Kentucky Transportation Cabinet Value Engineering Study Mountain Parkway Corridor – Construction Sequence 4

Item #10-168.00, Wolfe County

Final Value Engineering Study Report

Study Dates: March 9-13, 2015

TITLE: Bifurcate the roadway from Sta 570+00 to Sta 590+00 on one side

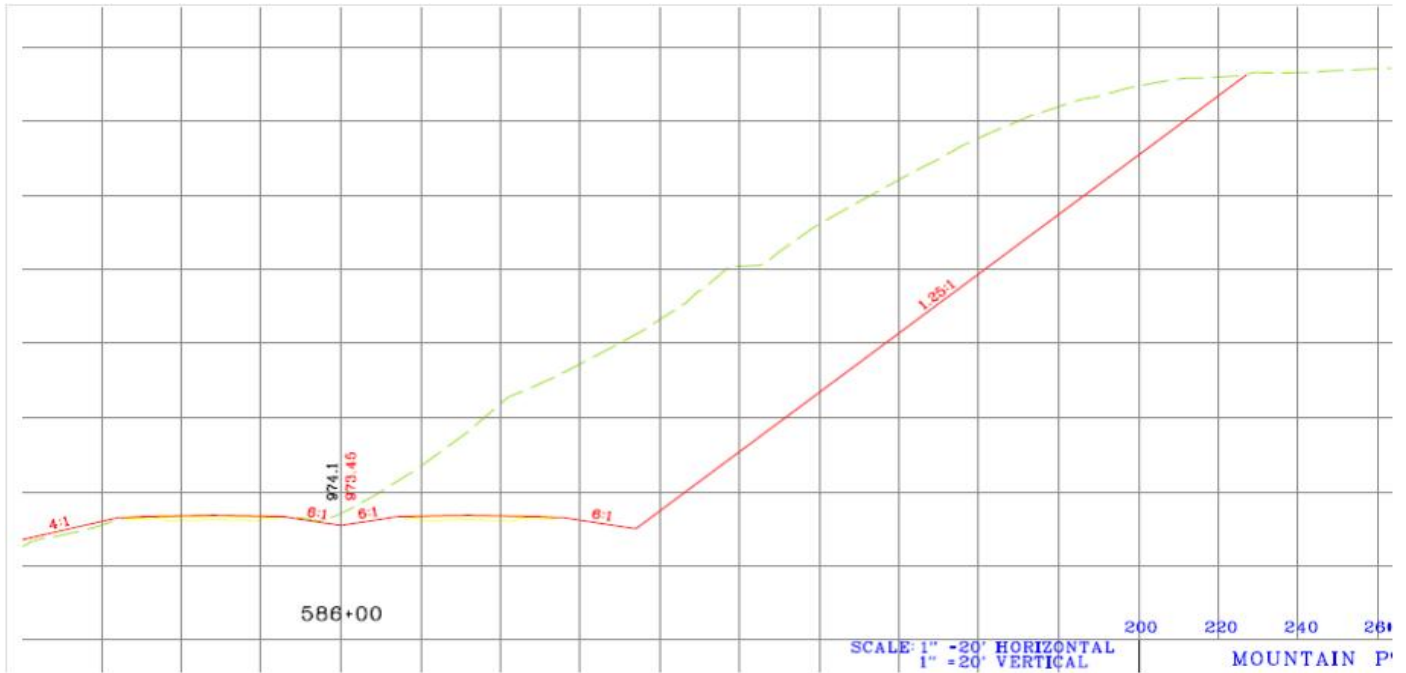
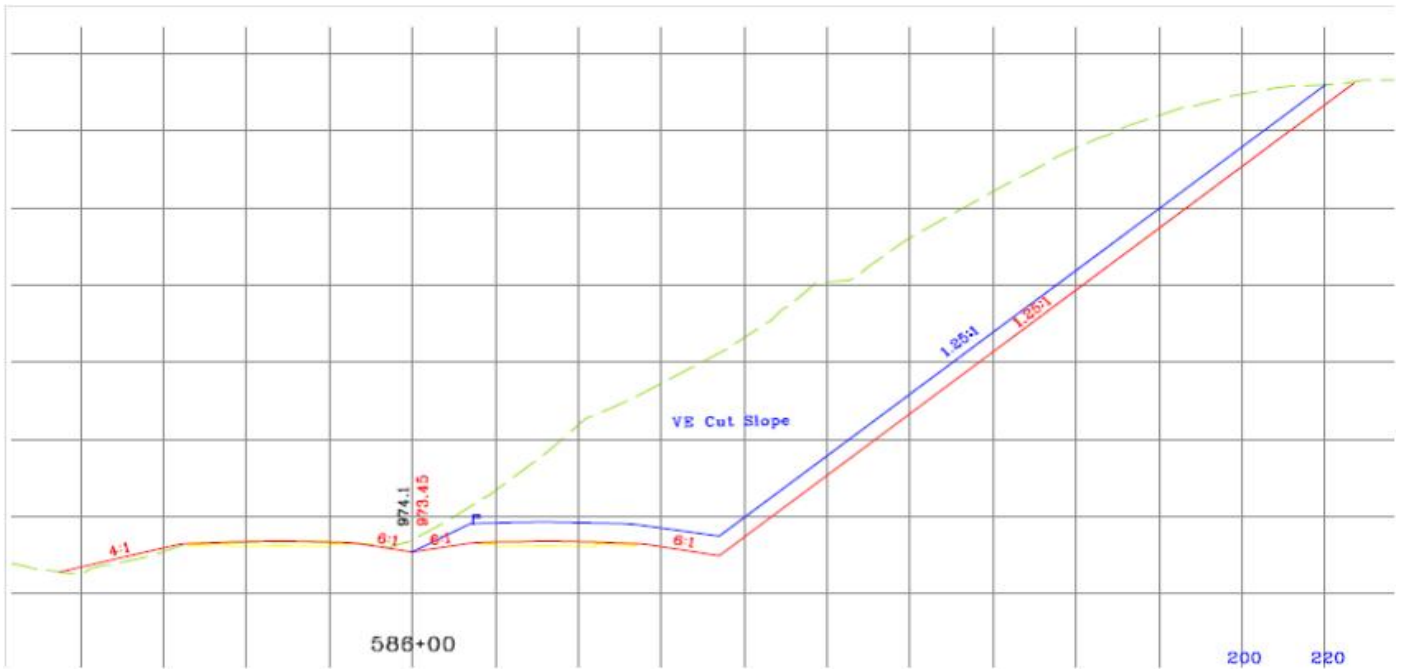
TITLE: Bifurcate the roadway from Sta 570+00 to Sta 590+00 on one side																			
FUNCTION: Convey Vehicles																			
BASELINE ASSUMPTION: The current design shows the east bound and west bound lanes at the same elevation along centerline throughout the entire corridor.																			
PROPOSED ALTERNATIVE: The proposed alternative would reduce the cross-sectional width of the roadway through the cut sections. The elevations for the lanes nearest the cut will be raised by approximately 5 feet. The grade change will be transitioned on each side of the cut.																			
BENEFITS		RISKS/CHALLENGES																	
<ul style="list-style-type: none"> Reduces quantity of excavation 		<ul style="list-style-type: none"> Requires installation of guardrail with end treatments 																	
<ul style="list-style-type: none"> Reduces construction time, due to reduction in roadway excavation quantities. 		<ul style="list-style-type: none"> Depending upon the durability of the rock. The high wall could erode, compromising the roadway section above 																	
<ul style="list-style-type: none"> 		<ul style="list-style-type: none"> The elevated lanes could shade the lower lanes, creating a cold spot in the winter 																	
<ul style="list-style-type: none"> 		<ul style="list-style-type: none"> The bench width required for elevated lanes could be compromised, due to fallouts or improper blasting practices 																	
<ul style="list-style-type: none"> 		<ul style="list-style-type: none"> 																	
<ul style="list-style-type: none"> 		<ul style="list-style-type: none"> 																	
<ul style="list-style-type: none"> 		<ul style="list-style-type: none"> 																	
<ul style="list-style-type: none"> 		<ul style="list-style-type: none">

The current plans call for 5.915 million cubic yards of roadway excavation for this eleven mile section of the Mountain Parkway. The proposed alternative reduces the cross-sectional width of the roadway through the cut sections, thus reducing the roadway excavation quantity. The travel lanes closest to the cut will be raised approximately 5 feet. The grade changes will be transitioned on the back station and ahead station ends of the cut.

TITLE: Bifurcate the roadway from Sta 402+00 to 465+00

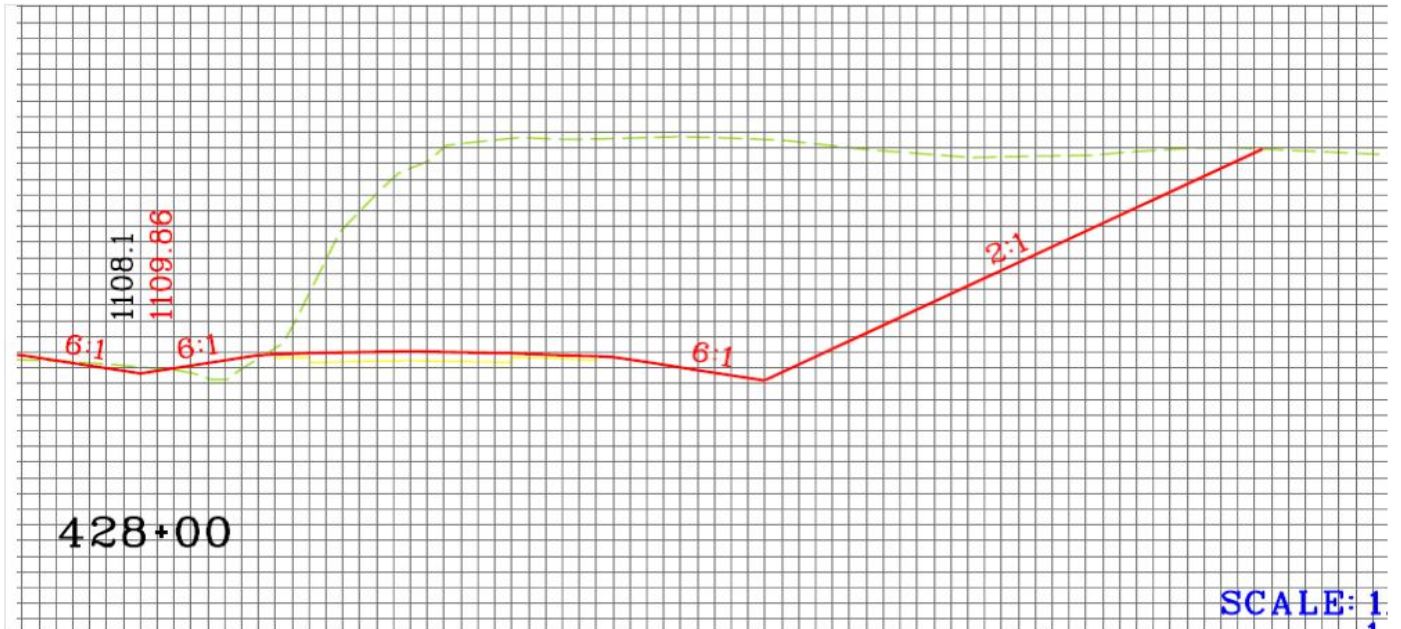
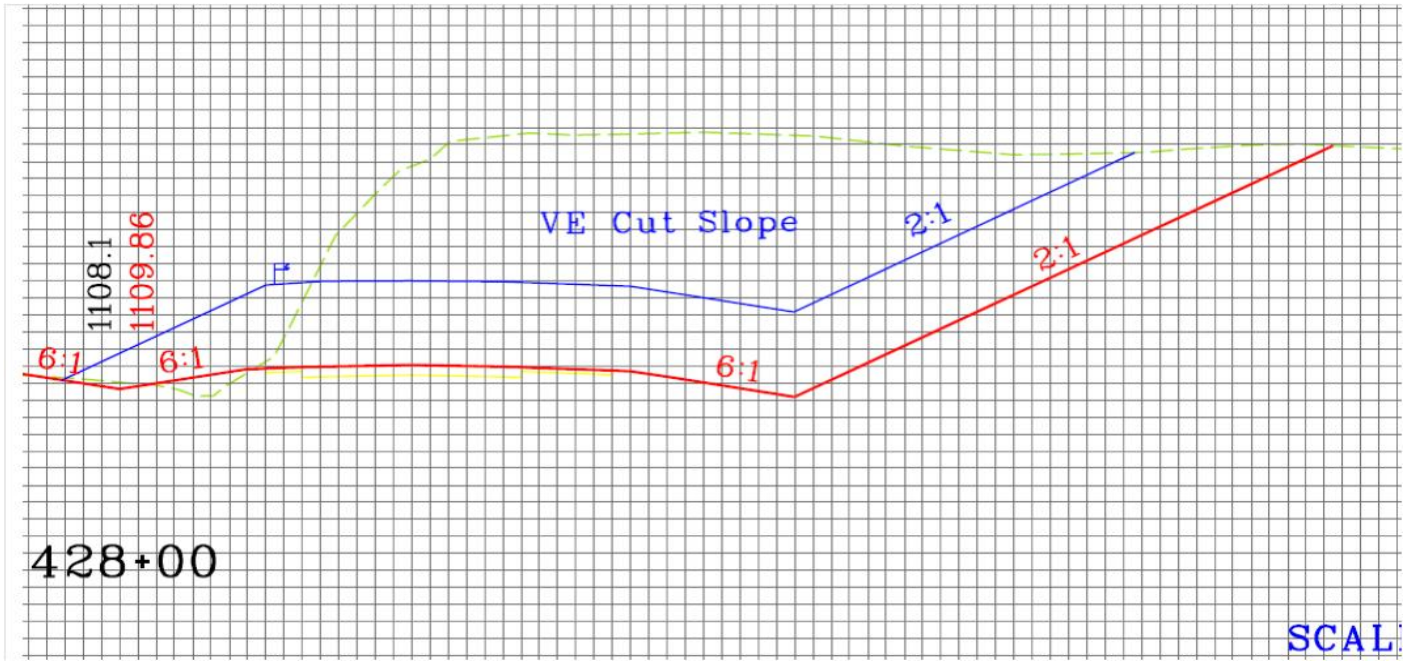
TITLE: Bifurcate the roadway from Sta 402+00 to 465+00																			
FUNCTION: Convey Vehicles																			
BASELINE ASSUMPTION: The current design shows the east bound and west bound lanes at the same elevation along centerline throughout the entire corridor.																			
PROPOSED ALTERNATIVE: The proposed alternative would reduce the cross-sectional width of the roadway through the cut sections. The elevations for the lanes nearest the cut will be raised by approximately 10 feet. The grade change will be transitioned on each side of the cut.																			
BENEFITS		RISKS/CHALLENGES																	
<ul style="list-style-type: none"> Reduces quantity of excavation 		<ul style="list-style-type: none"> Requires installation of guardrail with end treatments 																	
<ul style="list-style-type: none"> Reduces construction time, due to reduction in roadway excavation quantities. 		<ul style="list-style-type: none"> Depending upon the durability of the rock. The high wall could erode, compromising the roadway section above 																	
<ul style="list-style-type: none"> 		<ul style="list-style-type: none"> The elevated lanes could shade the lower lanes, creating a cold spot in the winter 																	
<ul style="list-style-type: none"> 		<ul style="list-style-type: none"> The bench width required for elevated lanes could be compromised, due to fallouts or improper blasting practices. 																	
<ul style="list-style-type: none"> 		<ul style="list-style-type: none"> 																	
<ul style="list-style-type: none"> 		<ul style="list-style-type: none"> 																	
<ul style="list-style-type: none"> 		<ul style="list-style-type: none"> 																	
<ul style="list-style-type: none"> 		<ul style="list-style-type: none">

The current plans call for 5.915 million cubic yards of roadway excavation for this eleven mile section of the Mountain Parkway. The proposed alternative reduces the cross-sectional width of the roadway through the cut sections, thus reducing the roadway excavation quantity. The travel lanes closest to the cut will be raised approximately 10 feet. The grade changes will be transitioned on the back station and ahead station ends of the cut.

TITLE: Leave existing alignment at Sta 150+00 to Sta 220+00 and go cross-country

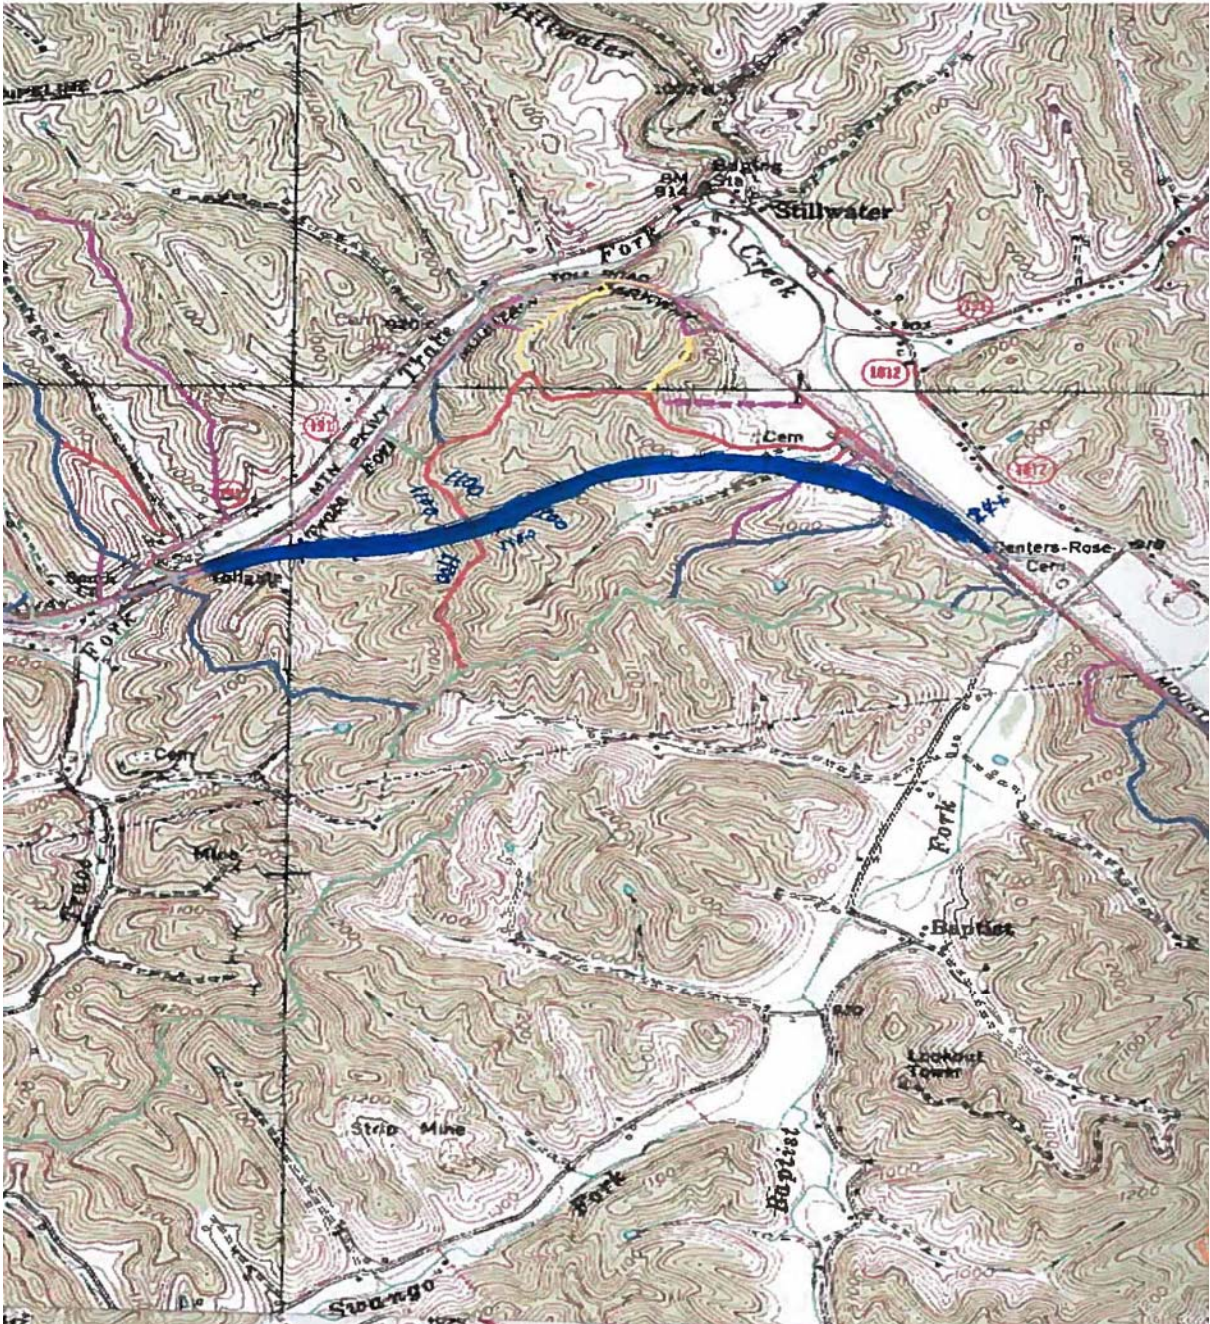
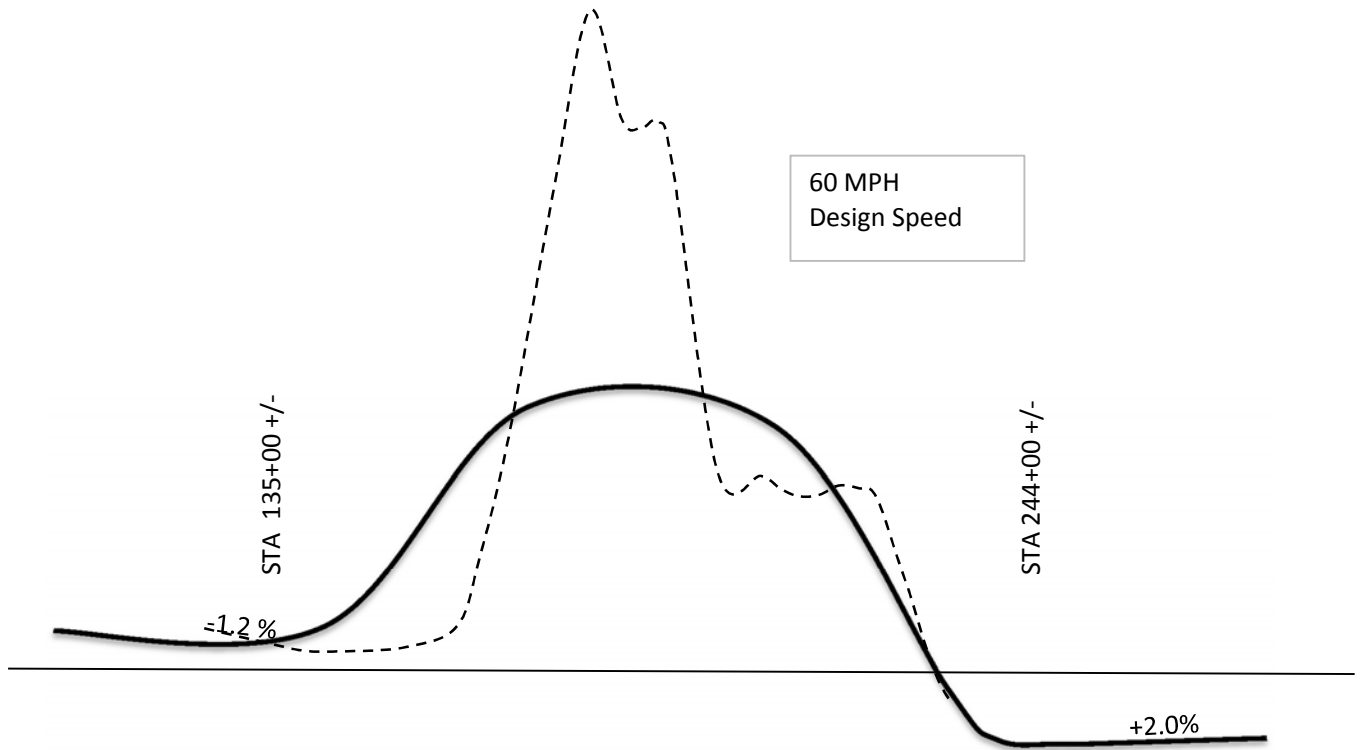
TITLE: Leave existing alignment at Sta 150+00 to Sta 220+00 and go cross-country								
DESIGN ELEMENT	Markup	BASELINE ASSUMPTION				PROPOSED ALTERNATIVE		
Description	%	Unit	Qty	Unit Cost \$	TOTAL \$	Qty	Unit Cost \$	TOTAL \$
Added roadway excavation			353000	5.00	1,765,000	703000	5.00	3,515,000
Reduced asphalt surface						-438	80.00	-35,040
Reduced asphalt base						-3157	70.00	-220,990
Reduced crushed stone base						-1475	26.50	-39,088
					1,765,000			3,219,883
(BASELINE LESS PROPOSED)								(1,454,883)

TITLE: Leave existing alignment Sta 530+00 to Sta 545+00 and go across country

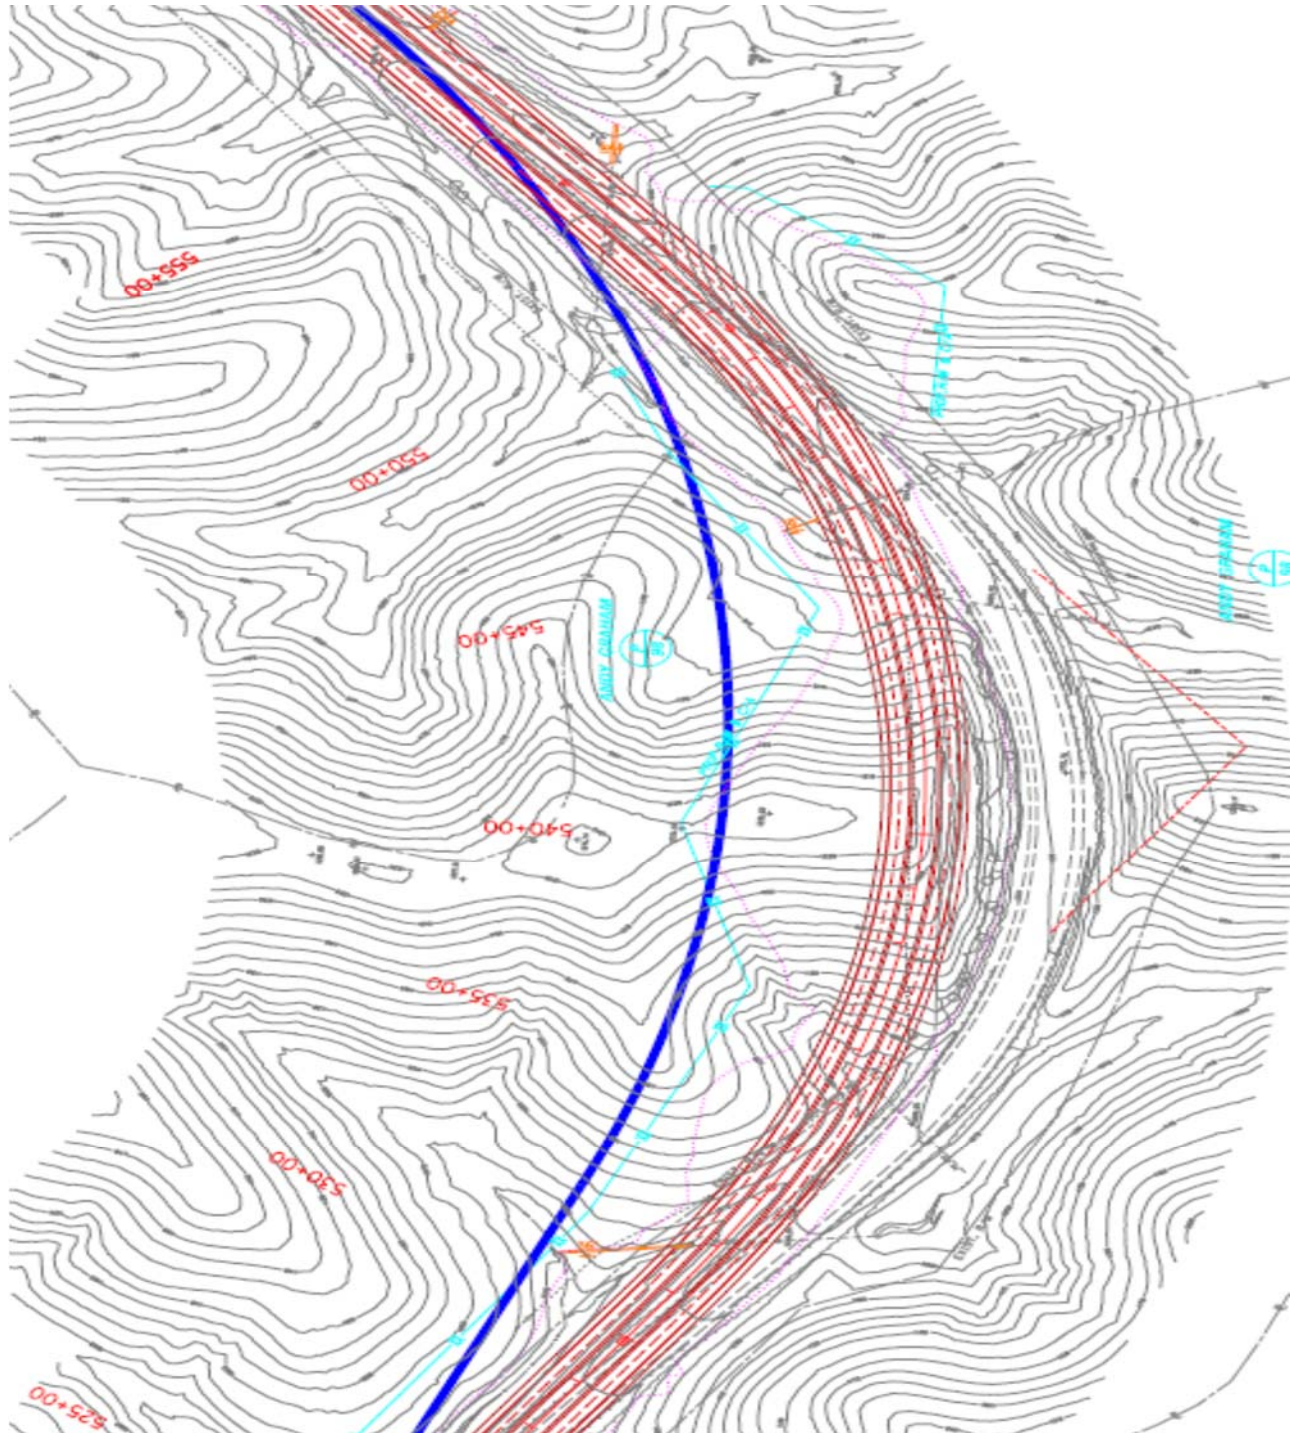
TITLE: Leave existing alignment Sta 530+00 to Sta 545+00 and go across country								
DESIGN ELEMENT	Markup	BASELINE ASSUMPTION				PROPOSED ALTERNATIVE		
Description	%	Unit	Qty	Unit Cost \$	TOTAL \$	Qty	Unit Cost \$	TOTAL \$
Added roadway excavation						500000	5.00	2,500,000
Reduced asphalt surface						-438	80.00	-35,040
Reduced asphalt base						-3157	70.00	-220,990
Reduced crushed stone base						-1475	26.50	-39,088
								2,204,883
(BASELINE LESS PROPOSED)								(2,204,883)

TITLE: Reconfigure KY 191 traffic interchange

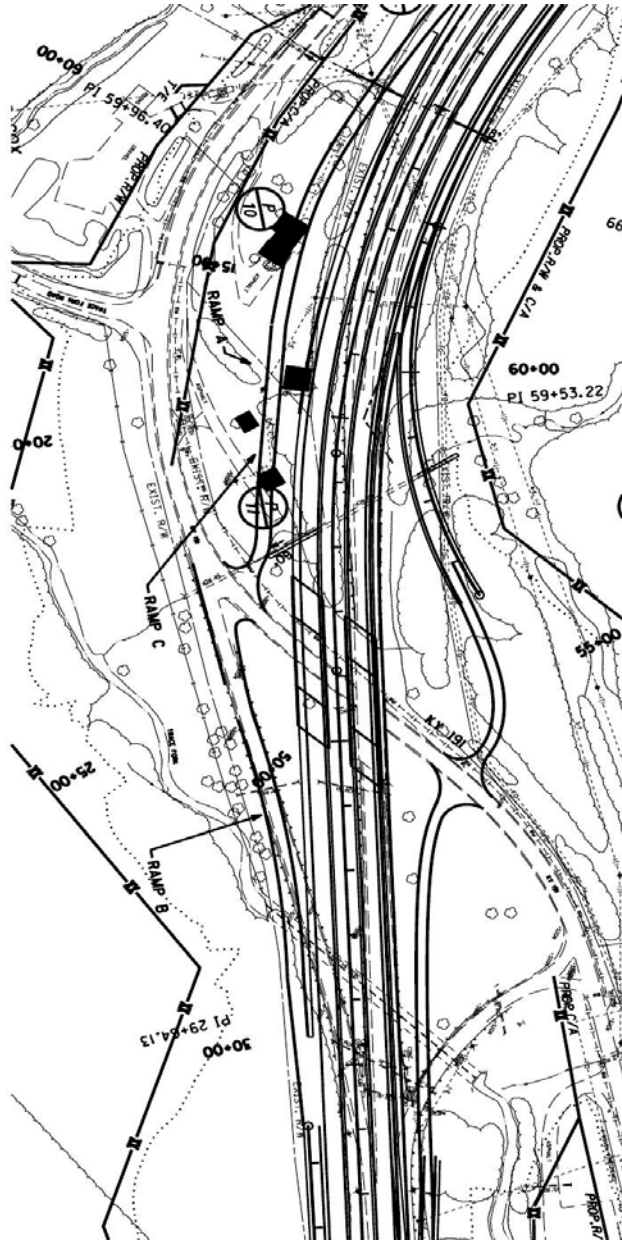
This alternative shifts Ramp A's taper west and Ramp D's taper east to provide parallel exit ramps approximately 500-feet in length. Ramp A would lengthen two culvert extensions and impact a channel which would increase in-lieu fees. Ramp D would also lengthen a culvert extension and could possibly increase impacts to the South Central Bell overhead line. Approximately 1,000 additional feet of ramp pavement would also be needed. All totaled, the cost of implementing the ramp improvements would be approximately \$375,000. The added length could make the ramp exits more visible, provide deceleration length and therefore, safer. However the ramp's daily Design Hour Volume (DHV) is 20, so that should also be considered when determining the need to make additional changes.

This will require that the acceleration and deceleration lengths need to be reviewed and finalized during the final design.
